*TOLEDO CITY
PLAN COMMISSION
REPORT*

August 14, 2014

**TOLEDO-LUCAS COUNTY PLAN COMMISSIONS
APPLICATION DEADLINE, AGENDA, STAFF REPORT AND HEARING
SCHEDULE - 2014**

SITE PLAN

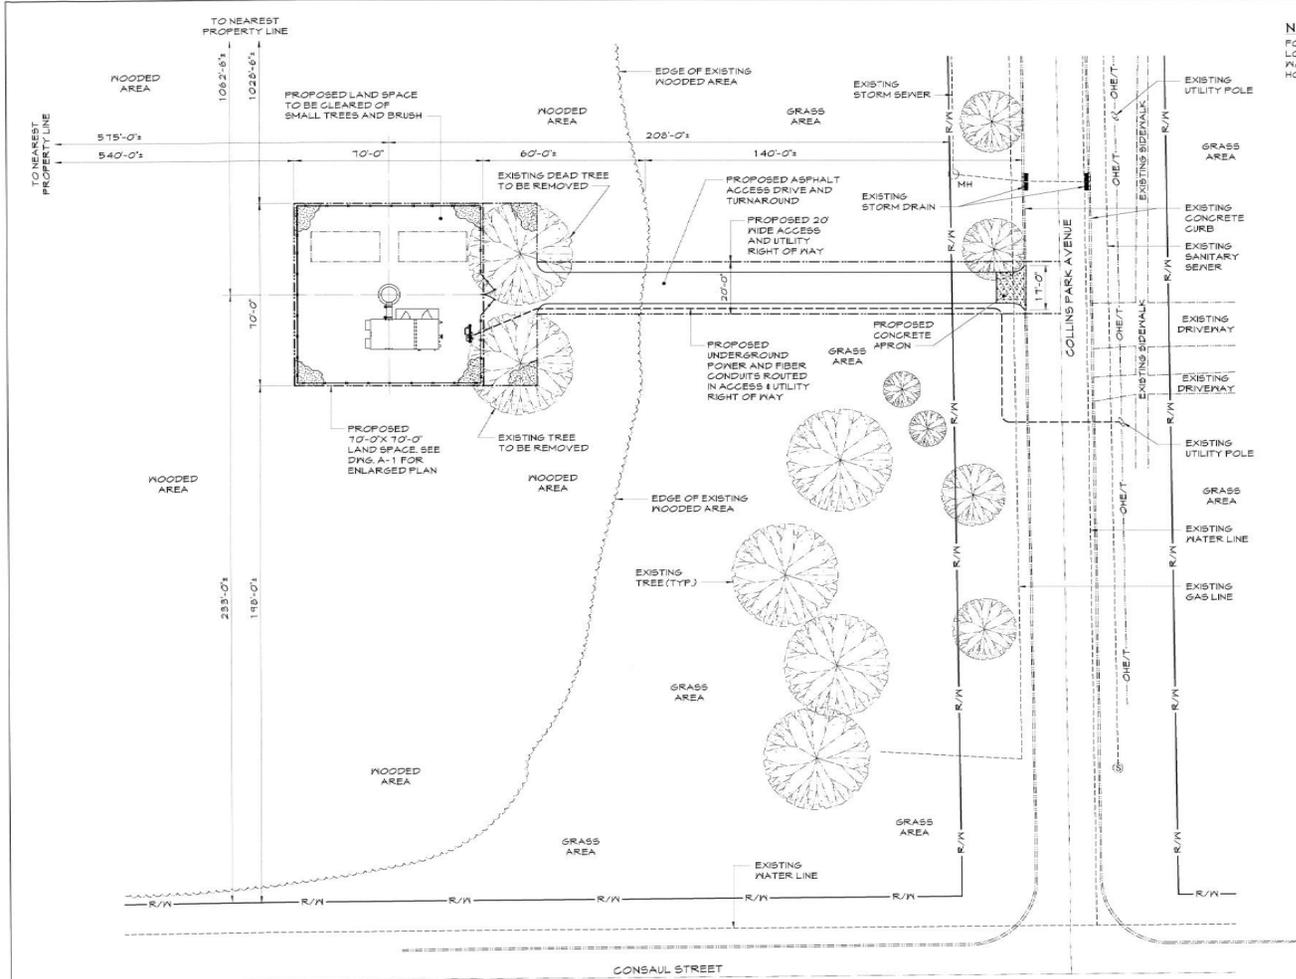
The applicant is proposing the use of an eight (8) foot high chain link fence with barbed wire and plantings evenly spaced every seven (7) feet on three (3) sides. The use of barbed wire is prohibited in all zoning districts, except industrial districts under certain conditions. In addition, The Division of Building Inspection objects to the use of barbed wire in this location. The prohibition of barbed wire is included as a condition of approval.

Pursuant to TMC 1108.0203 - Type A buffers consist of four (4) canopy trees and fifteen (15) shrubs per one hundred (100) linear feet. The applicant is requesting a waiver of the required Type A buffer along the western side of the leased area. This area currently consists of mature trees and is not visible from the public right-of-way. Staff supports a waiver of the Type A buffer in this area, however, requires plantings consistent with a Type A buffer be installed along the remaining three (3) sides and a solid eight (8) foot high privacy fence or wall be installed around the perimeter of the wireless facility.

13. Although the structure depicted in the proposed site drawings is labeled an equipment shelter, any construction and/or erection of an occupied structure will require construction documents stamped by a licensed design professional to be submitted to the Division of Building Inspection for plan review and approval showing the structure's construction to be in compliance with the Ohio Building Code and the associated mechanical, electrical codes and fire codes.
14. The Division of Building Inspection objects to the use of barbed wire, prohibited by TMC 1105.0303, particularly as this location is in a Parks and Open Space (POS) zoning district used by the public for recreation and not in an industrial zoning district.

SITE PLAN

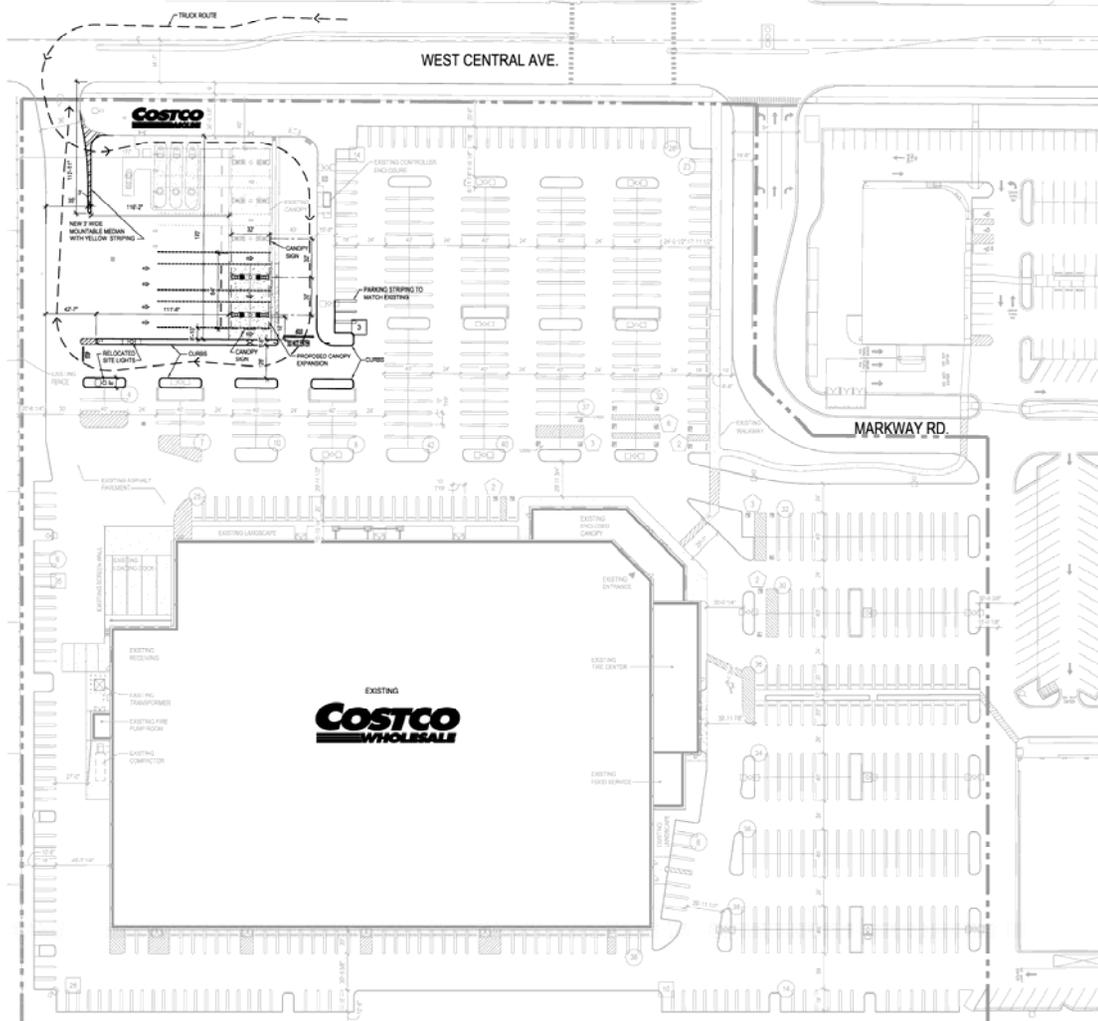
This is an amendment to an existing Special Use Permit, originally granted via Ordinance 200-06, to add two additional gas pump islands for the existing Costco fuel facility located north of the Costco retail building on Central Avenue. The fuel facility is part of the larger Costco development developed in 2006. Currently this facility has 3 islands with a total of 6 pumps (12 pumping stations). Costco is seeking to expand this to 5 islands with a total of 10 pumps (16 pumping stations). This addition will result in the elimination of 36 parking spaces currently dedicated for the Costco retail building. However a total of 637 spaces for the retail establishment remain available, parking remains compliant.

A landscape plan has been submitted as part of the Special Use Permit amendment. This expansion is interior to the site and will result in a 5’6” median separating the fuel facility from the parking lot. Additionally, the site is in compliance with the Regional Commercial standards for frontage greenbelts.

SITE PLAN

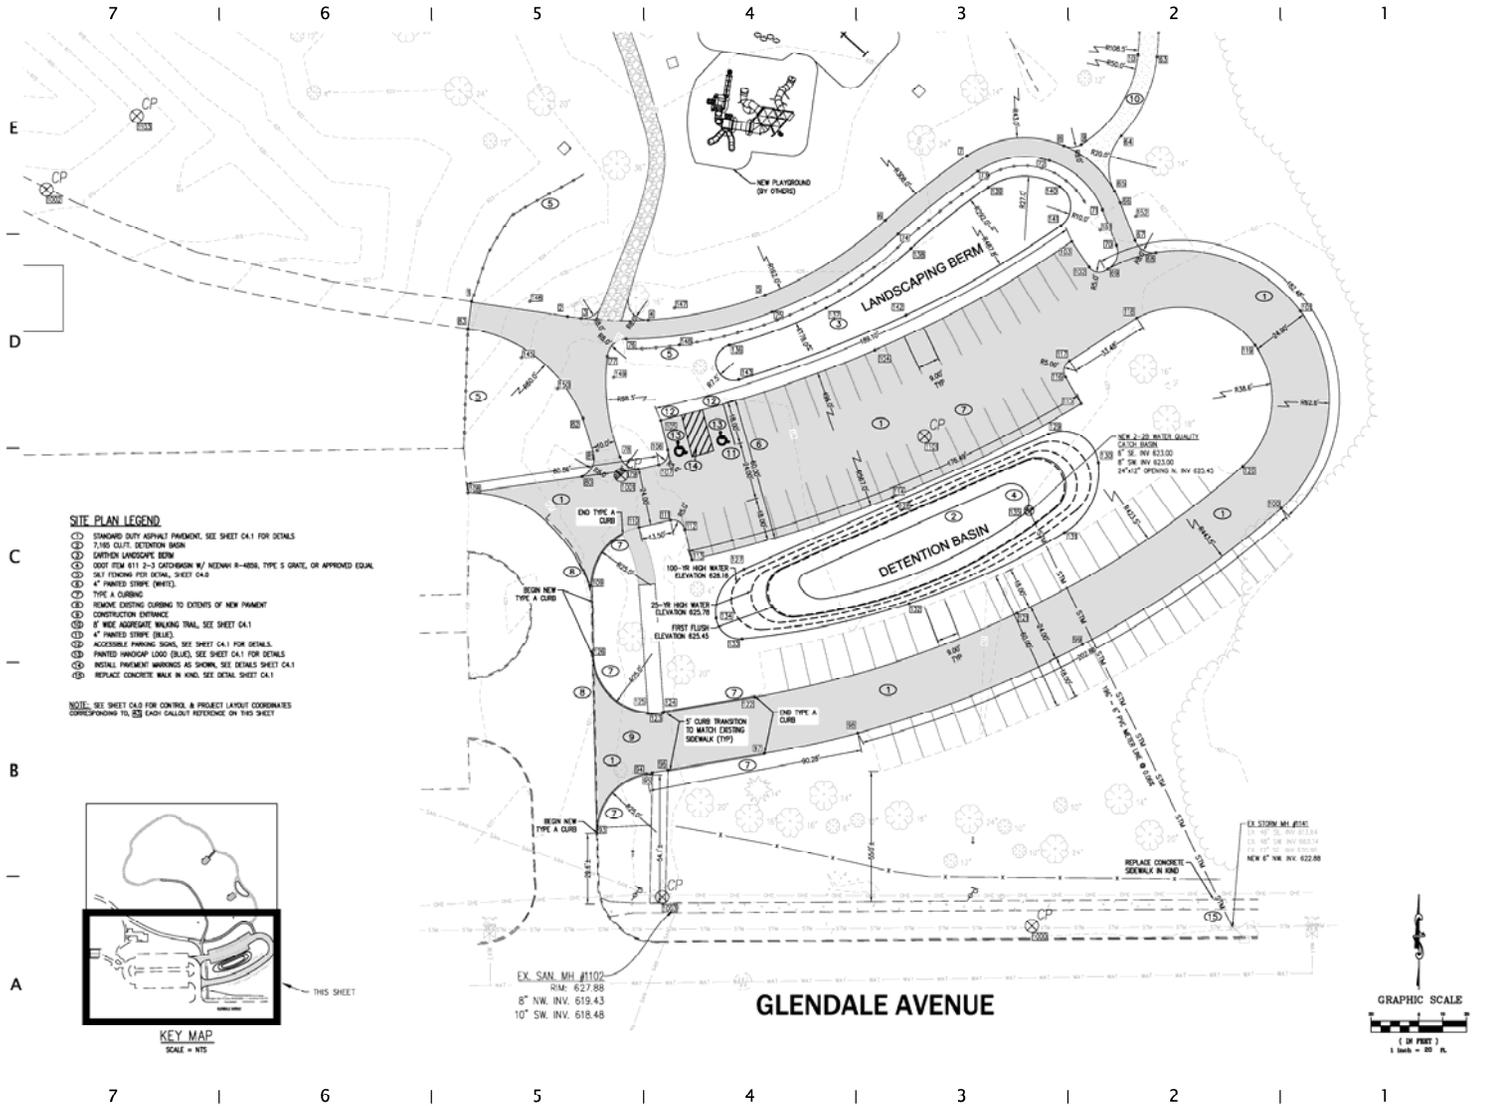
Pedestrian walking and bicycle trails currently exist throughout the development. The new pedestrian trail will loop from the new parking area, along the wood line and connect to an existing “Stub” trail that currently ends at the existing playground area. Not only will the new loop trail serve as a point of recreation, it will also provide connectivity to the two (2) new picnic shelters and the new playground. Upon completion, the existing playground equipment will be removed and the area will be reseeded providing additional open space displaced by the new development. The Division of Transportation has requested that the drive aisles be widened to twenty-five (25) feet wide and the southern drive be aligned with the access drive of the opposing west parking lot.

The site is existing and per TMC§1114.0500 Appearance Upgrade for Nonconforming Development, the applicant is only required to bring the landscaping closer into compliance with the 2004 zoning code. The applicant submitted a detailed landscape plan for review. Existing mature trees currently exist and will serve as a greenbelt along the Glendale Avenue frontage. These trees are consistent with the mature landscaping along the existing Glendale Avenue parking area. In addition, the landscape plan indicates that a rain garden will be used for detention purposes. Multiple existing trees will be relocated and new trees will be installed around the new parking lot.

16. Dumpster location(s) shall have a concrete pad and be surrounded by a solid wooden fence or a masonry screen enclosure with landscaping and shall not be located in any required setbacks, **shall be noted on revised site plan.**

SITE PLAN AS SUBMITTED

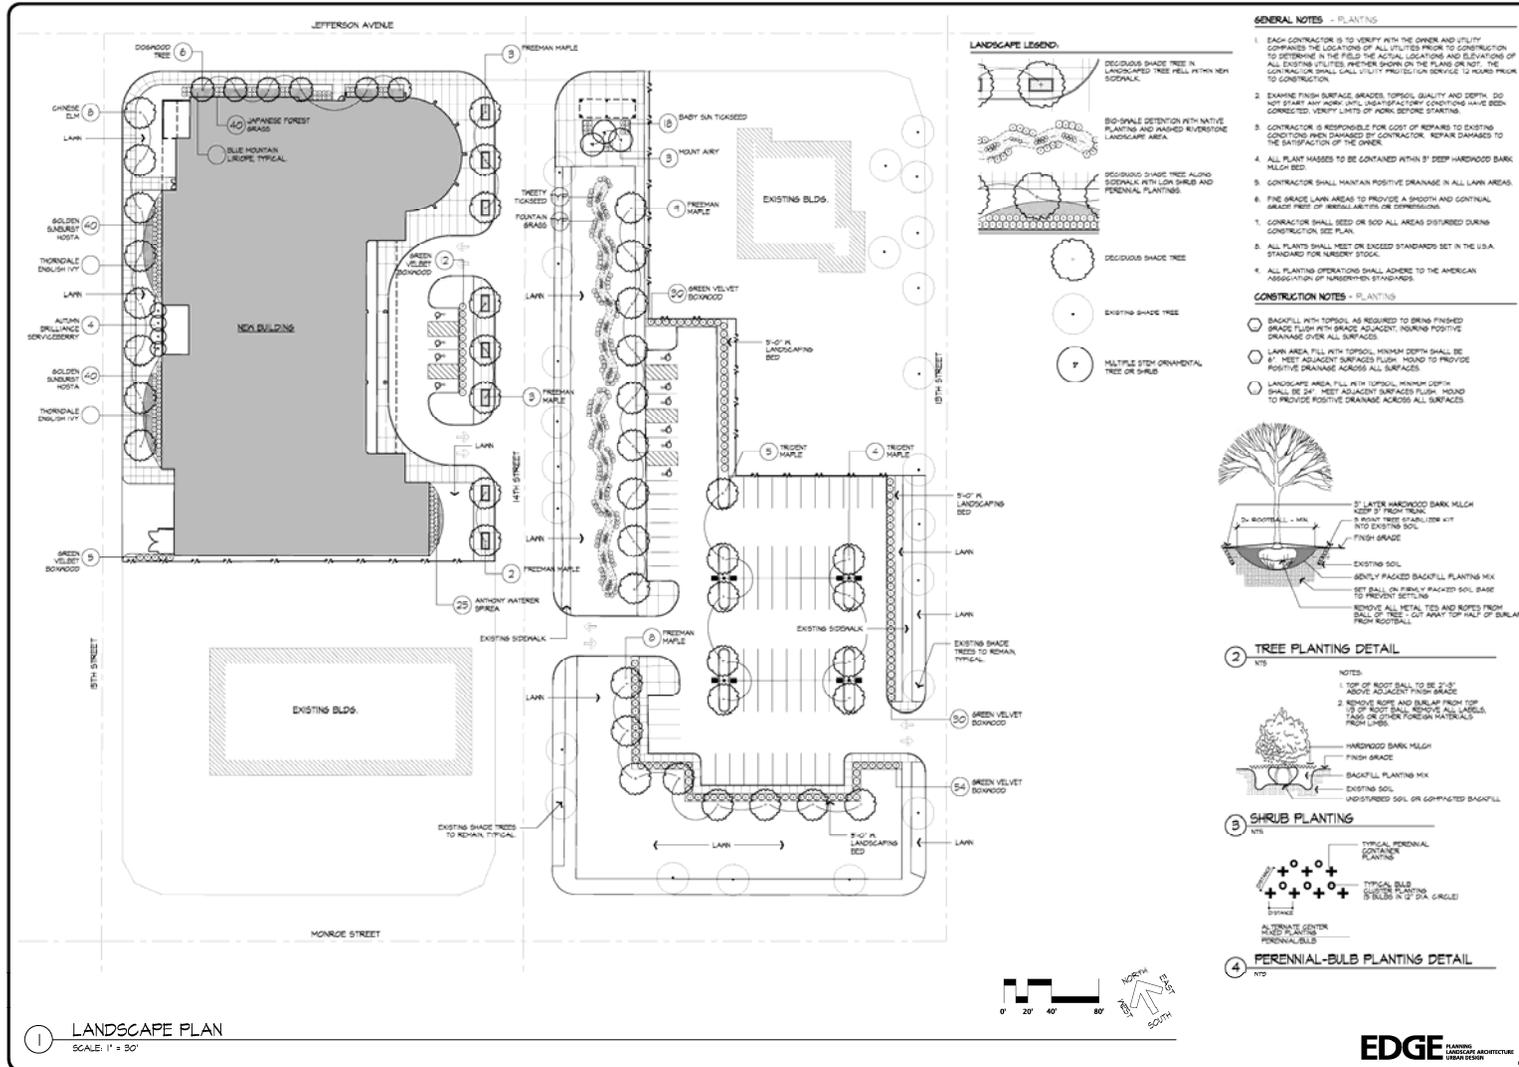
The site plan indicates 74 parking spaces allocated for the clinic. This is 94 parking spaces short of the required 168 parking spaces with a transit stop. The clinic provides services for an underserved population. A significant portion of their patients do not drive or use public transportation. An alternative parking plan will need to be submitted to the Plan Commission for review and approval prior to any building permits being issued. This plan must detail the type of alternative proposed and the rationale for such a proposal, including supporting research on or documentation of parking demand for the proposed use. The applicant is proposing to use curb cuts onto 14th and 13th Street to access the main parking lot. Access to the main building will be off of 14th Street for drop off and pick up.

The site is within the Monroe Street Urban Neighborhood Overlay, therefore the applicant is required to comply with the Urban Landscape standards of the zoning code. The site plan shows the building situated along the Jefferson Avenue frontage between 15th and 14th Street. A landscape strip is provided around the perimeter of the building along street frontages. In addition, street trees are proposed along 14th Street on the east side of the building. Additional trees will need to be located within the property in front of the building along 14th Street. A forty-four (44') foot greenbelt is proposed along the parking lot on the east side of 14th Street. A fifty-nine (59') foot greenbelt is shown along Monroe Street for the parking lot. The corner of Monroe and 14th would be an ideal location for a sign (no sign location was designated on the plan). If a sign is installed at this location it should be a low profile sign to reflect the character of the Monroe Street corridor. A five (5') foot landscape buffer will be installed along the 13th Street frontage. Given the size and character of the parking lot a metal tube or solid bar fence shall be installed in the landscaping for the parking lot.

Per TMC 1108.0304.A., a land use buffer is required along adjacent properties. The landscape plan for the parking lot does not meet this requirement. The parking area on the northeast side of the parking lot that abuts the property to the north does not indicate any type of buffer. The revised landscape plan shall comply with TMC 1108.0304.A.

A chain link fence with barbed wire is located on the south side of the building adjacent to the Taylor Cadillac site. The applicant should work with Taylor Cadillac to have that fence removed and then relocated to tie into the building. This will help with the aesthetics of the site and yet still provide security for both sites.

The site plan indicates that the dumpster for the clinic is located at the southwestern corner of the building. The proposed location is in compliance with TMC 1108.0304.B *Dumpster and Trash Receptacle Screening*. This section states that dumpsters shall not be located in the public right-of-way. The proposed location meets the TMC requirement.

35. The north elevation indicates that the entrance is in a different location than the site plan. This will need to be clarified in the revised elevations or site plan.
